22 ESBWR PRA CHANGES

The ESBWR Design Certification PRA is being developed in parallel with plant design details. Already, significant safety benefits have been added to the ESBWR design based on PRA insights. To account for the effects of design changes on the PRA model, a PRA model update is performed so that the changes to PRA results can be quantified, evaluated, and applied to the design process. An update takes several months to perform. As such, it is a static representation of the plant that is based on the design information accumulated up to a specified point in time. The design phase is a dynamic process because additional detailed design information is still being developed in order to implement the functional design described in the Design Control Document. These design details enhance the understanding of the structures, systems, and components in the PRA model, and thus reduce uncertainties and eliminate assumptions. Continuing development of design details has a positive effect on the risk profile; however, the published PRA results do not account for up-to-date design information.

The PRA model update process accounts for this by including a "delta document," i.e

Figure 22.3-1 Small LOCA ATWS Event Tree

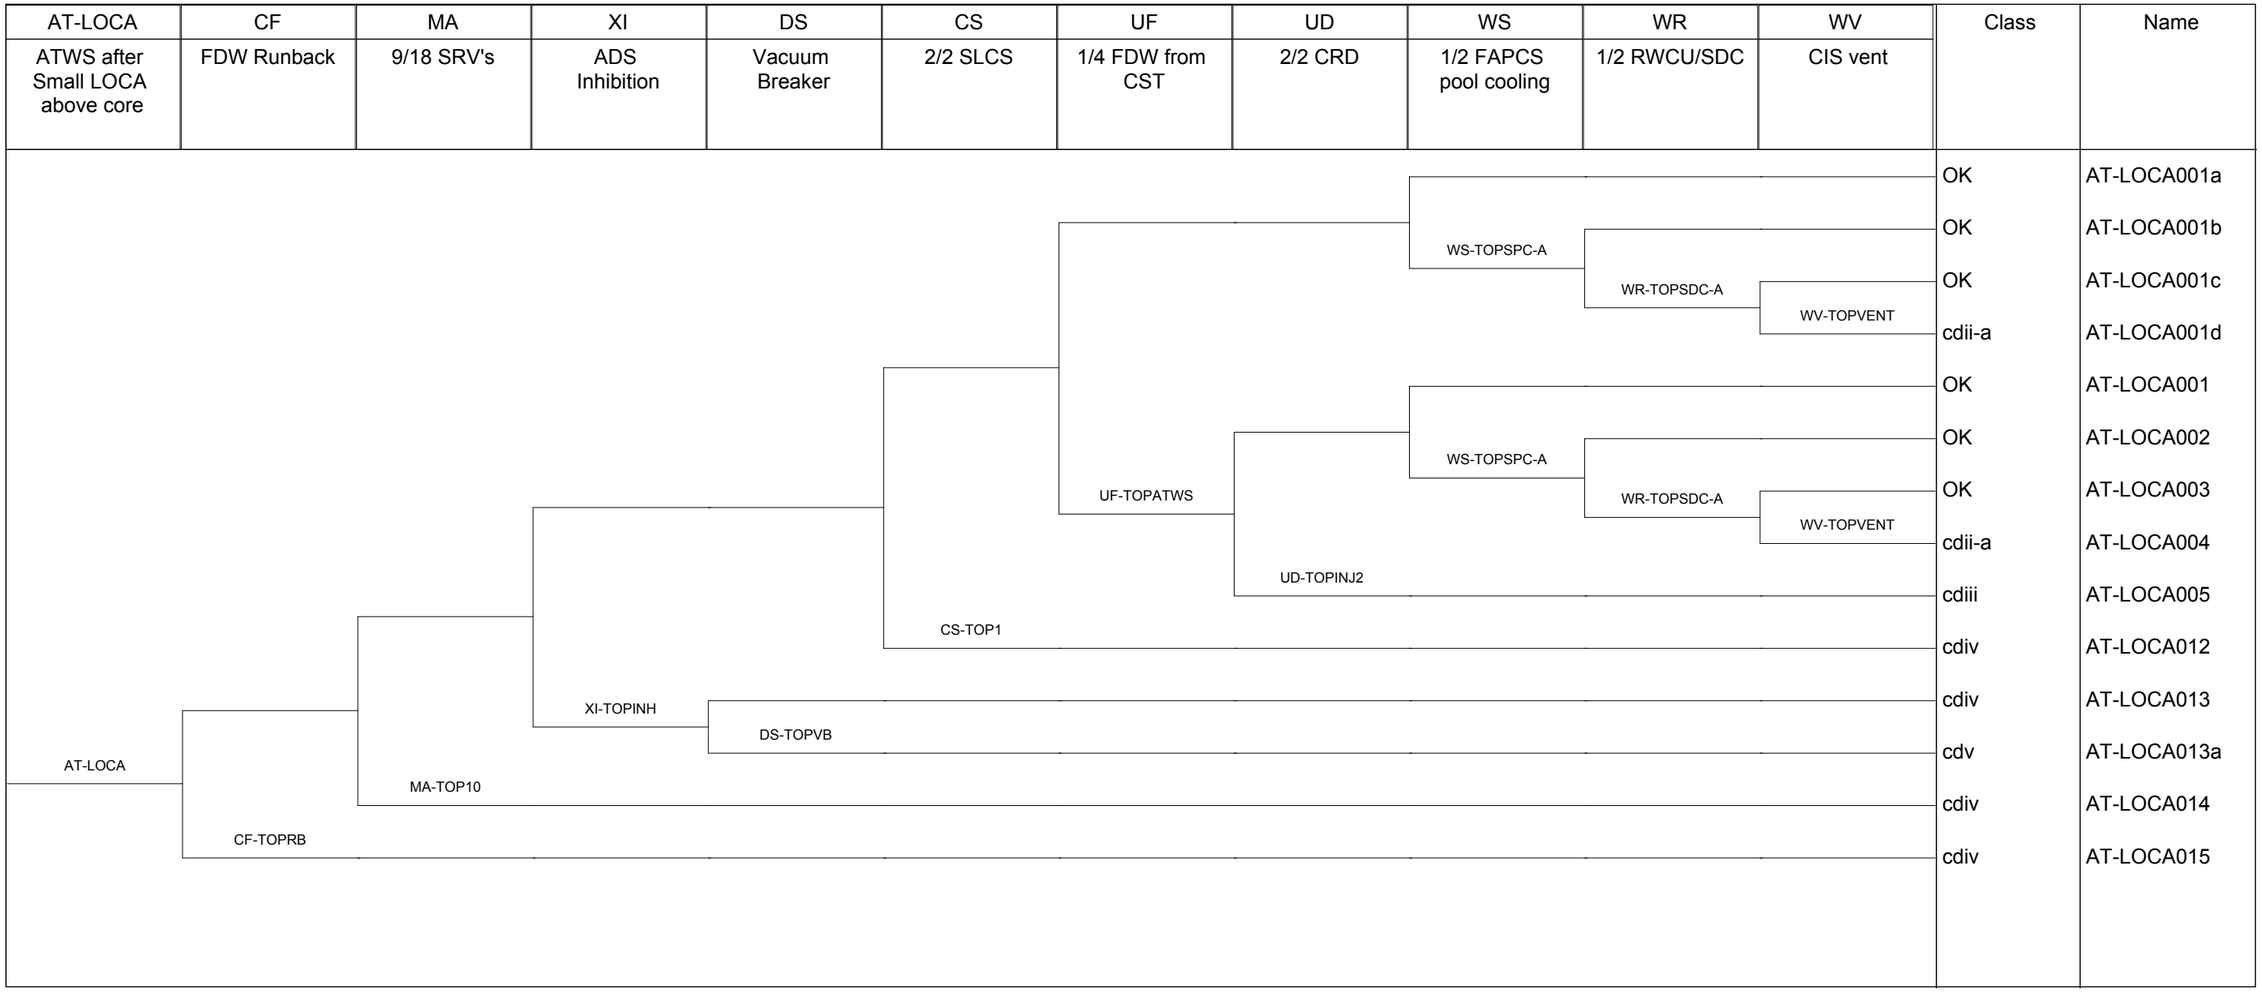
- AT-LOCA (Small LOCA ATWS) – Added sequence AT-LOCA013a
- AT-T-FDW (Loss of Feedwater ATWS) – Added sequence AT-T-FDW016a
- AT-T-GEN (General Transient ATWS) – Added sequence AT-T-GEN-24a
- AT-T-IORV (Inadvertently Opening of Relief Valve ATWS) – Added sequence AT-T-IORV012a
- AT-T-LOPP (Loss of Preferred Power ATWS) – Added sequence AT-T-LOPP016a
- AT-T-SW (Loss of Service Water ATWS) – Added sequence AT-T-SW007a

(4) In the Small LOCA ATWS (AT-LOCA) event tree, the event for feedwater injection (UF) has been added prior to event UD (2/2 CRD). This resulted in new sequences AT-LOCA001a (core ok), AT-LOCA001b (core ok), AT-LOCA001c (core ok), and AT-LOCA001d (cdii-a).

Figure 22.3-7 Break Outside Containment in Feedwater Line A Event Tree

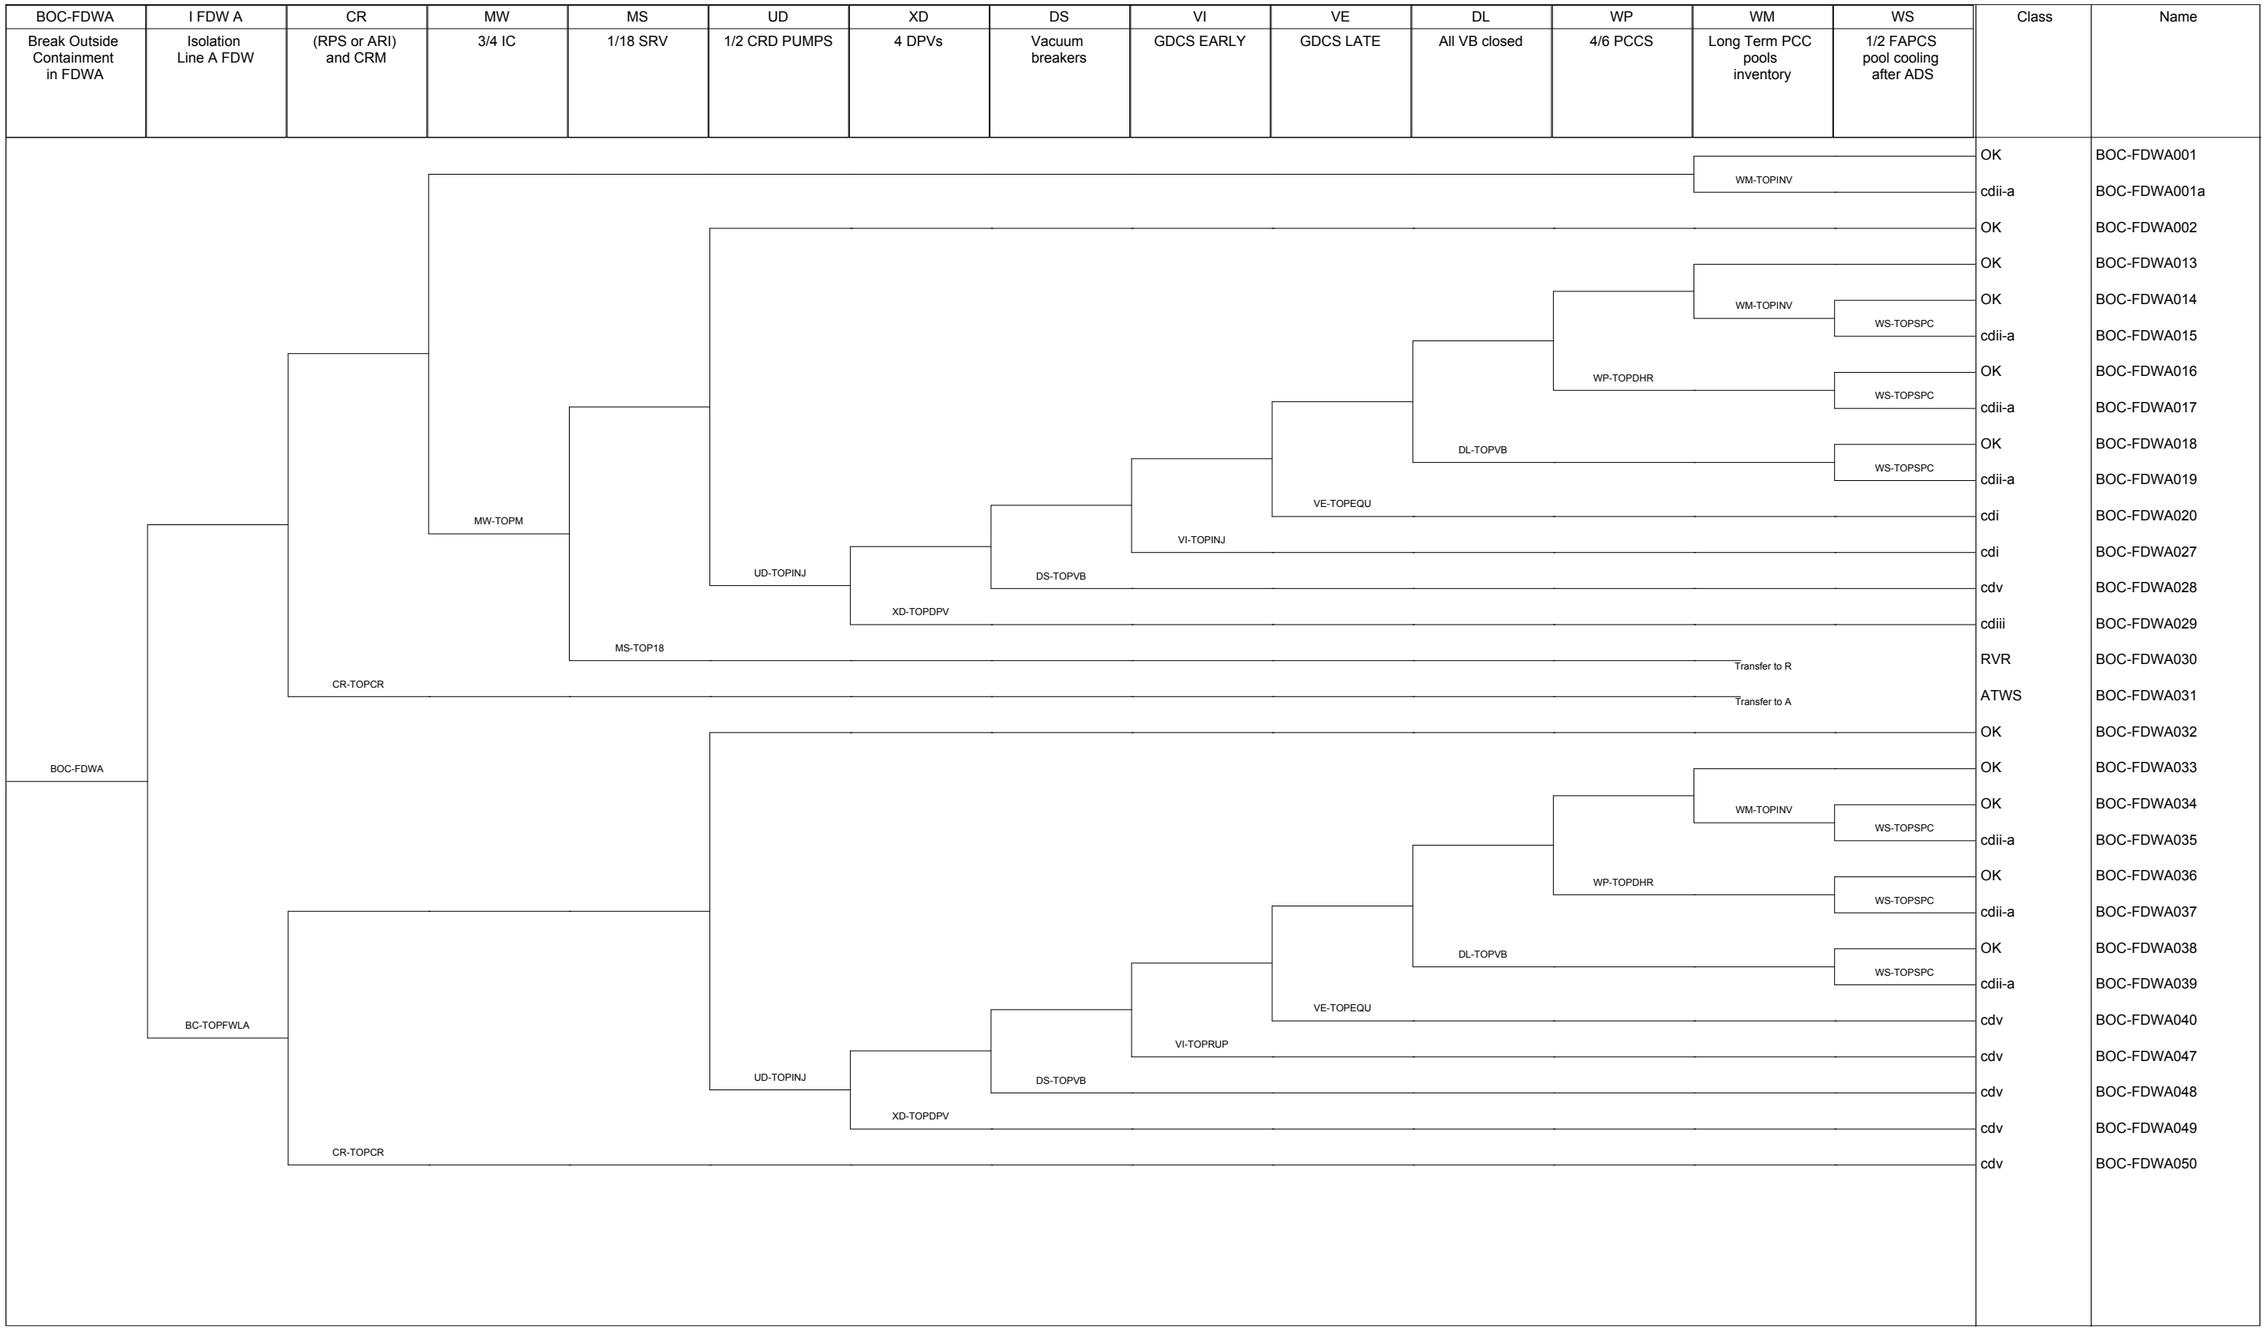
(1) BOC-FDWA (Break Outside Containment in Feedwater Line A) – Replaced initiator %BOC-FDWA with a gate named BOC-FDWA, which also included the ISLOCA initiating events. The FAPCS to RWCU/SDC piping interfacing system LOCA has been evaluated further, which was described in Subsection 2.3.3.4. The location of the FAPCS to RWCU/SDC piping interfacing system LOCA would generate a plant response similar to a Train A feedwater line break outside containment. Therefore, it is appropriate to include the ISLOCA initiating event in the BOC-FDWA event tree.

Figure 22.3-8 Break Outside Containment in Feedwater Line B Event Tree

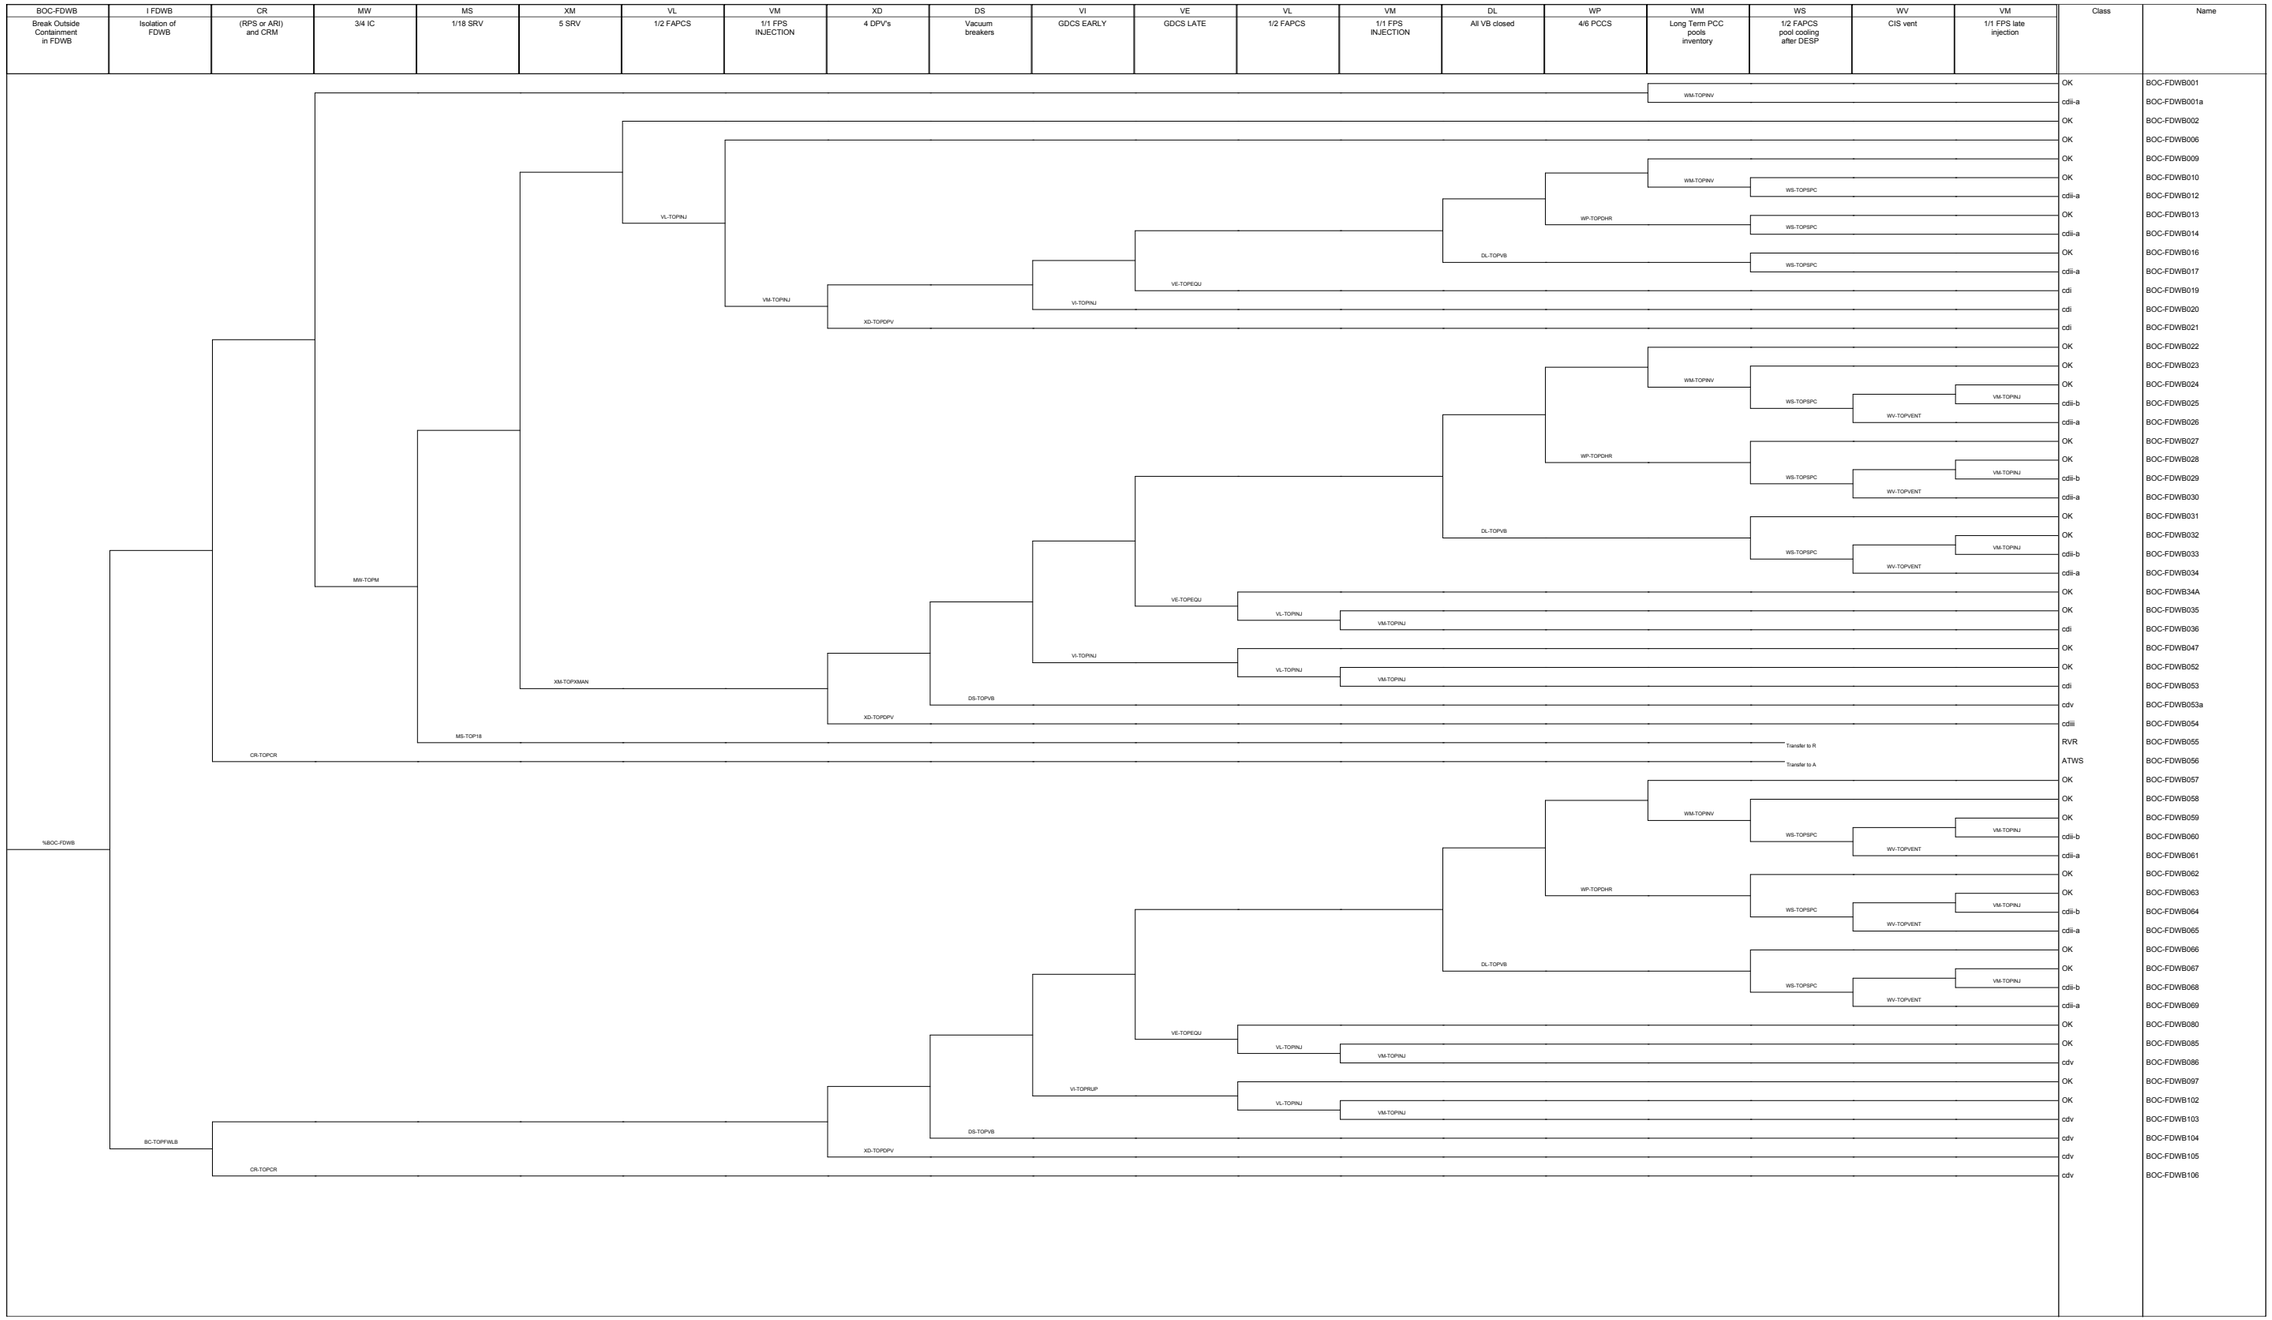
(2) In the Break Outside Containment in Feedwater Line B (BOC-FDWB) event tree, a new sequence BOC-FDWB053a has been added to address the failure of event DS (vacuum breakers) after ADS success for conservatism.

Figure 22.3-15 Medium Liquid LOCA Event Tree

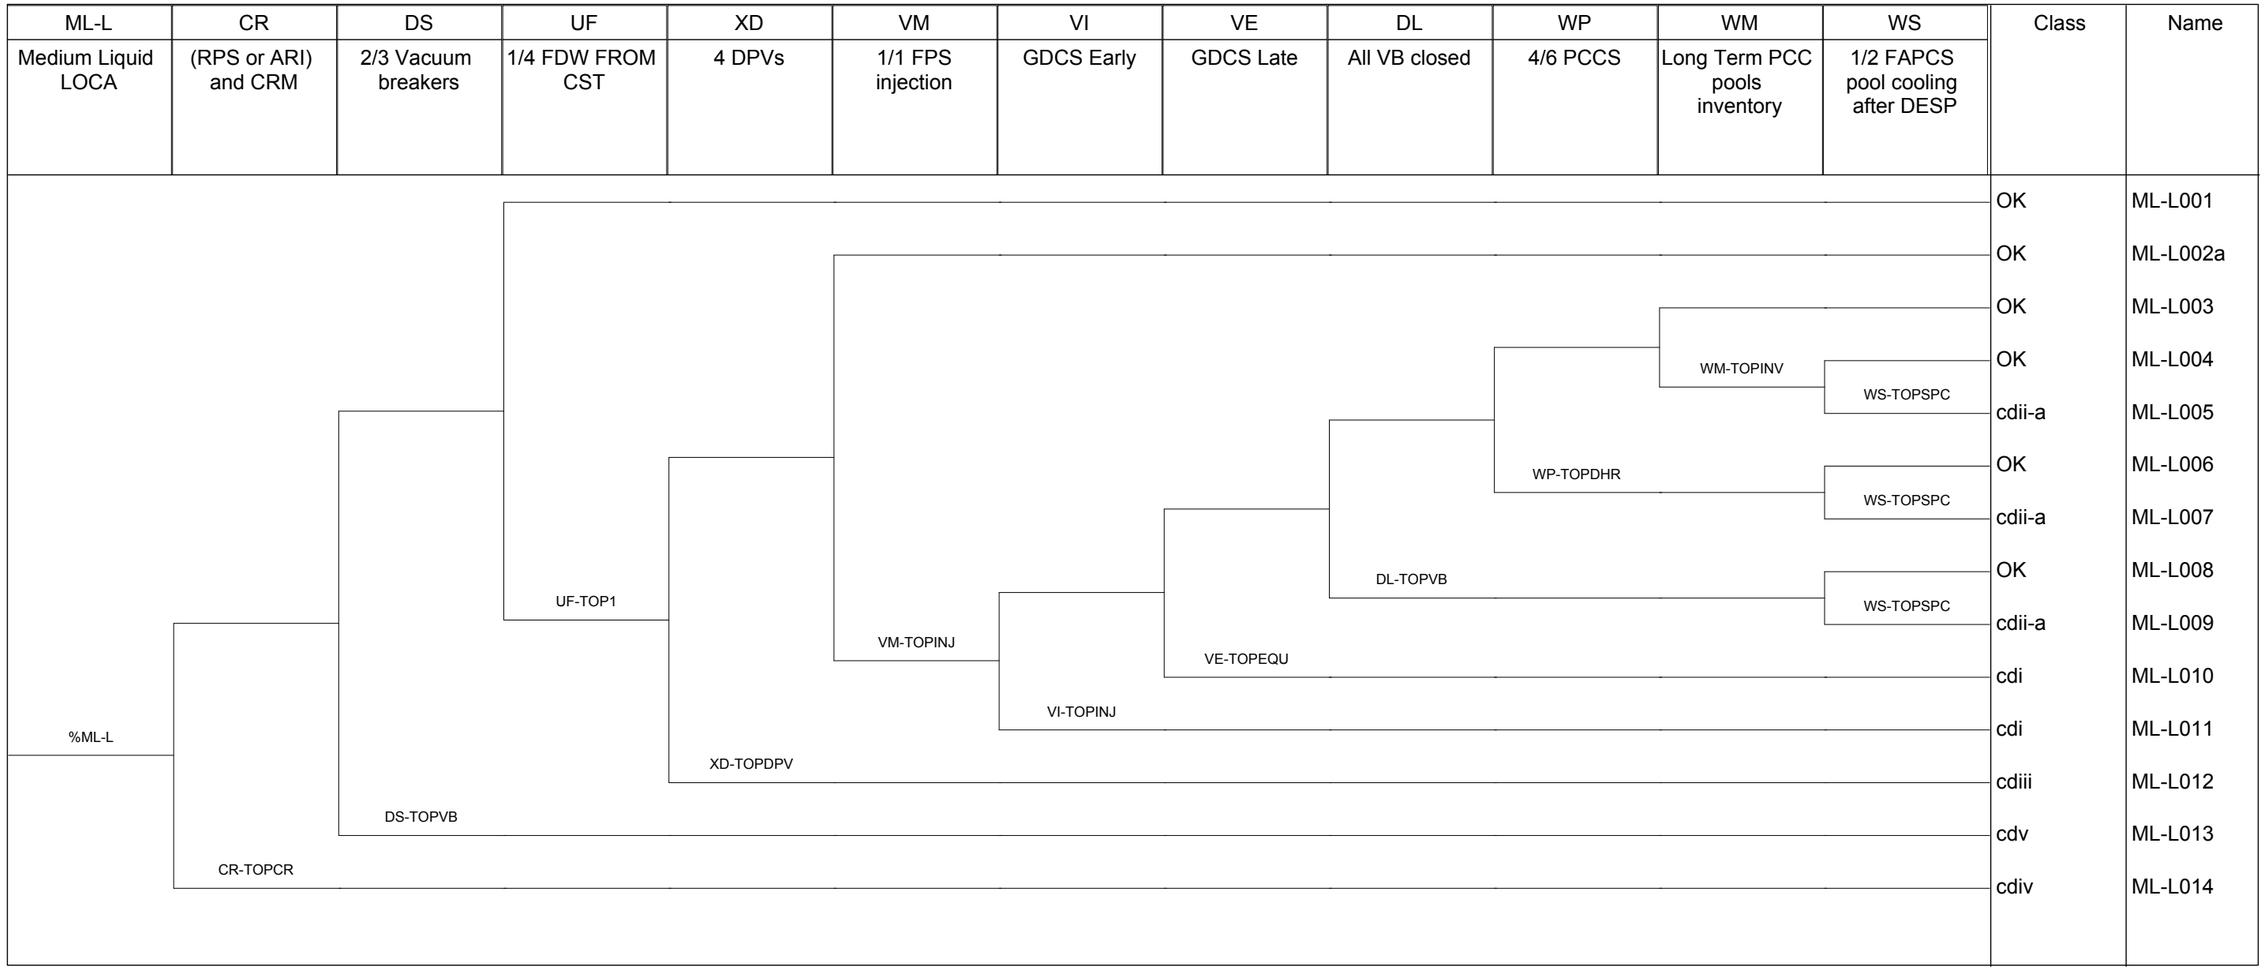
(5) In the Medium Liquid LOCA (ML-L) even tree, the event for firewater injection (VM) has been moved past the depressurization event (XD). This change was resulted from the thermal hydraulic runs, which indicates that for the limiting case (drain line break), pressure did not reduce significantly and the proposed design for the intermediate pressure fire-pump would not be able to inject.
